APPLICATION FOR A RESIDENTIAL SITE IMPROVEMENT PERMIT/ CONSTRUCTION AUTHORIZATION FOR AN ON-SITE WASTEWATER SYSTEM, NEW WELL INSTALLATION, OR REPAIR OF EXISTING WELL

STREET ADDRESS: 9029 Miriam Drive

SOIL/SITE EVALUATION for ON-SITE WASTEWATER SYSTEM

IMPROVEMENT PERMIT

Soil & Site Evaluation Map

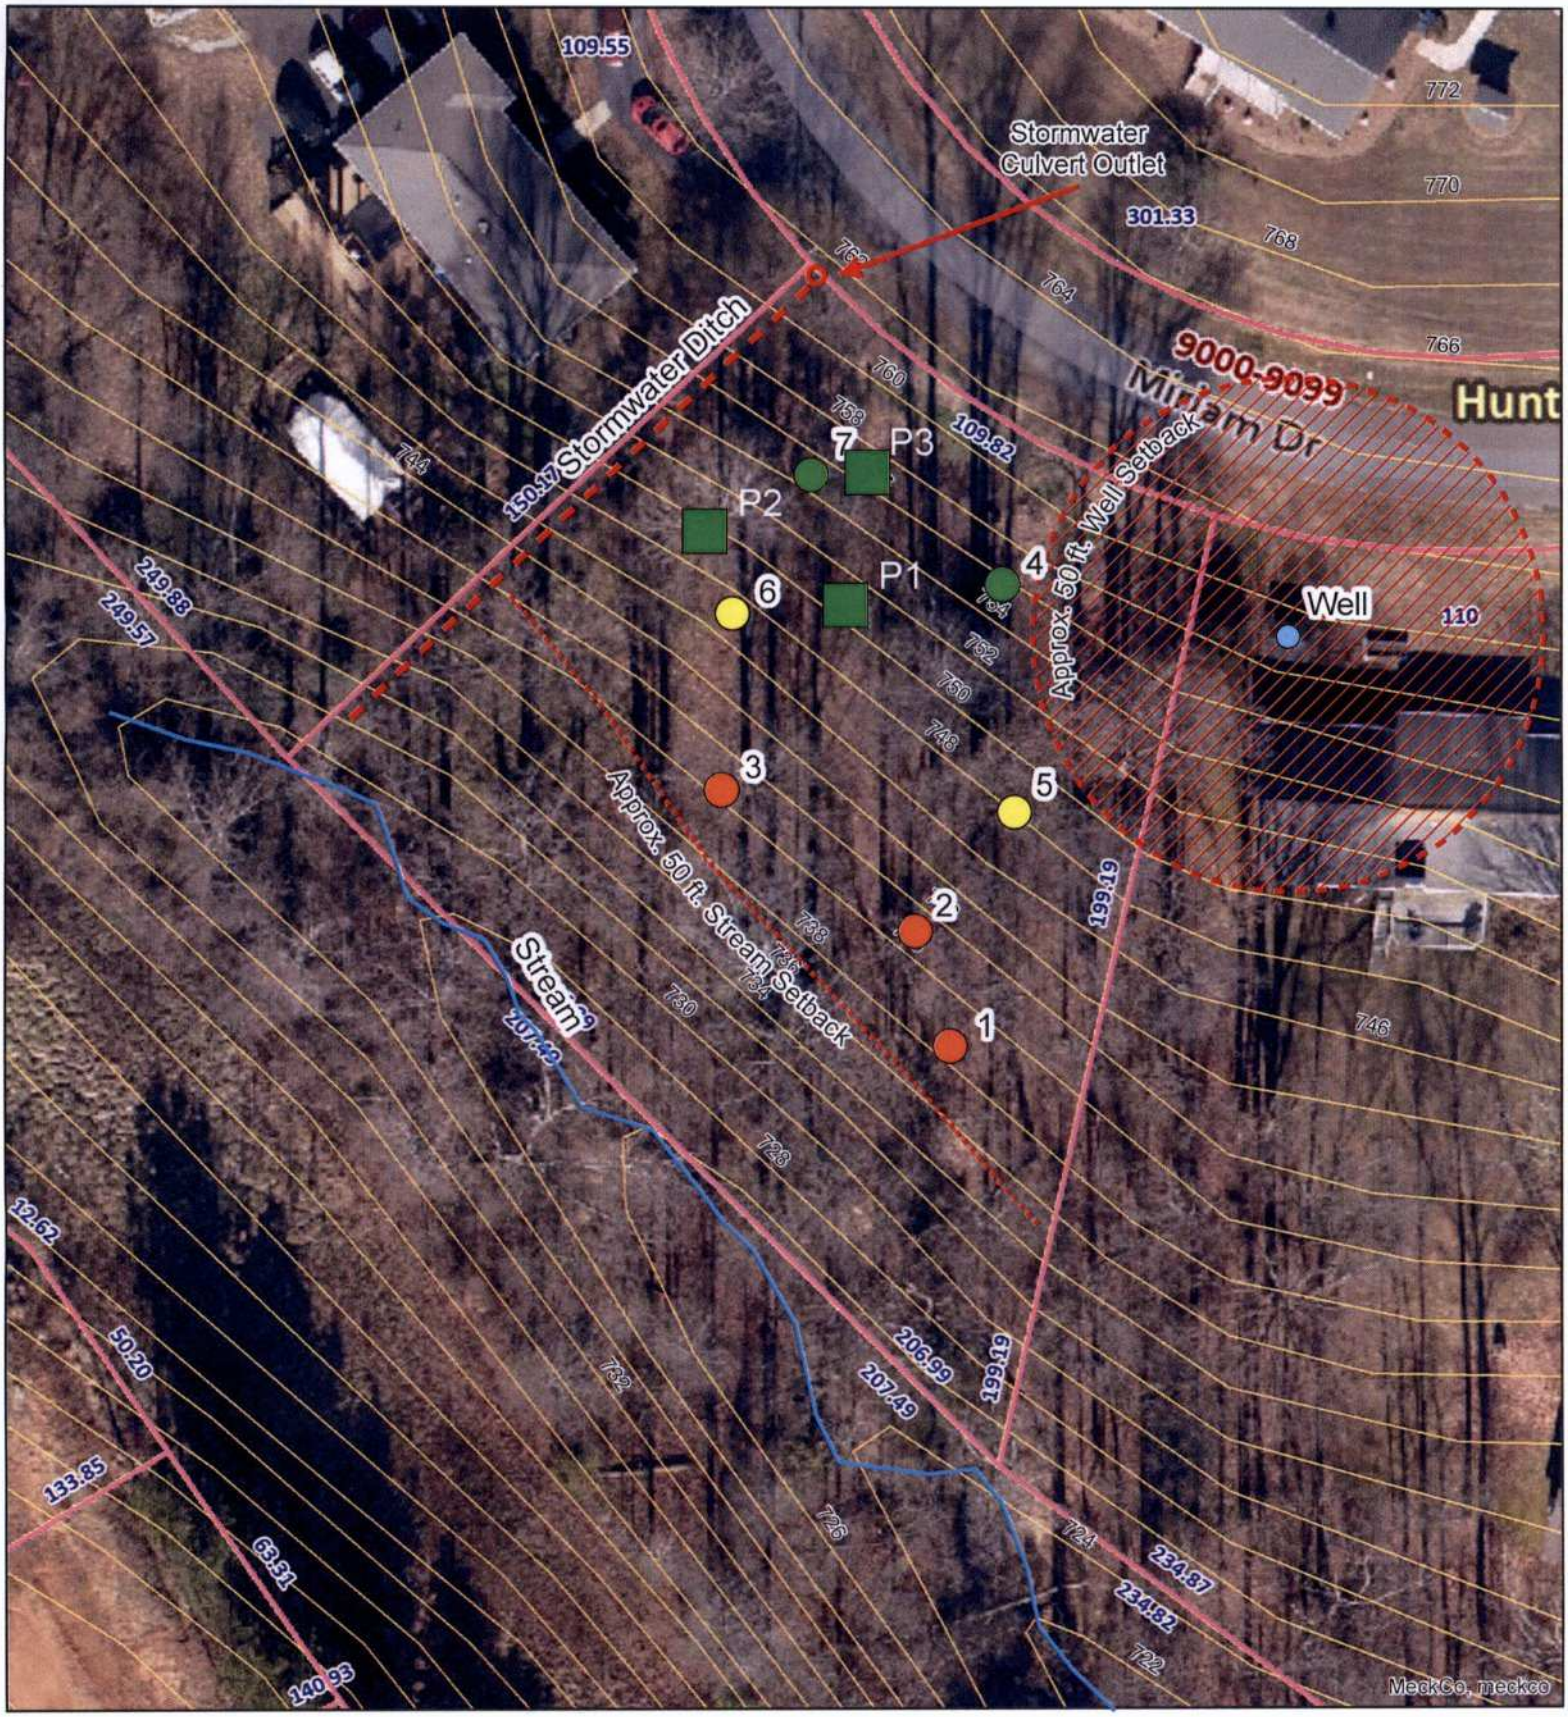
Comments: Lot appears to be repair exempt based on survey plat recorded prior to Jan. 1, 1983. However, there is available space for shallow placed repair area using 0.25 LTAR and/or drip repair area utlizing 0.10 LTAR in the rear of lot (borings 1, 2, & 3).

Description	Initial System	Repair System
Available Space (.0508)		
System Type(s)		
Site LTAR	0.30	
Maximum Trench Depth (low side of trench)	27"

Soil & Site Evaluation Map

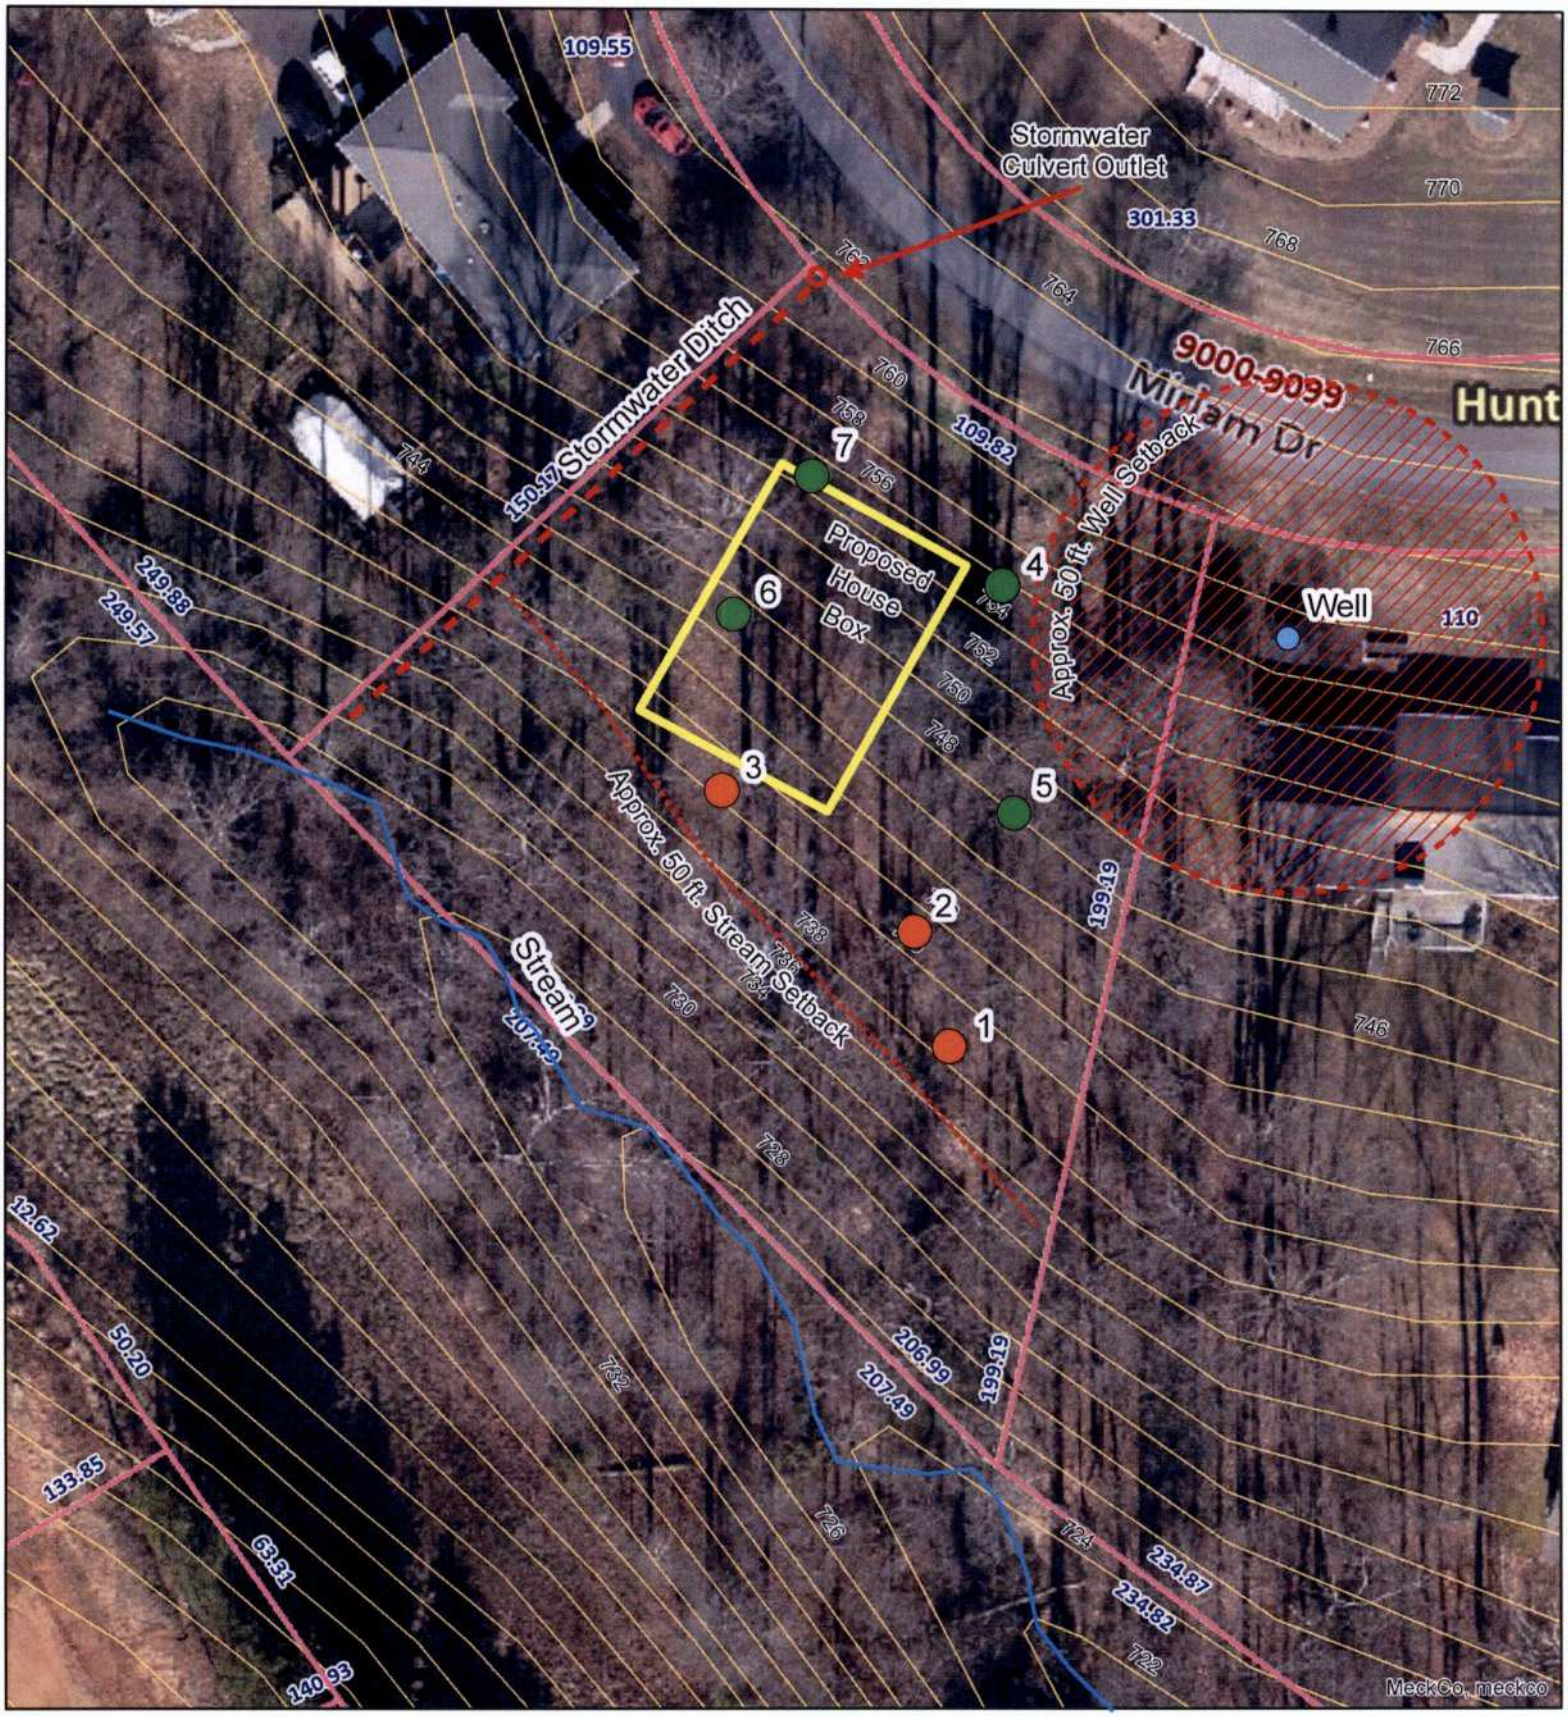
Comments: Need soil pits excavated to confirm saprolite suitability, to determine depths to soils wetness vs litho, and to determine US soil depth boundary for system area. The lot appears to be US due to insufficient space resulting from proposed house, setbacks to the following: neighboring well, stream on back of lot, & a stormwater ditch, and US soil depths in borings #1, #2, & #3. In addition, the proposed house is a slab or basement foundation which will have an increased side setback required. Site could potentially be suitable if the proposed house is moved and the size is altered around the suitable soils area and system layout.
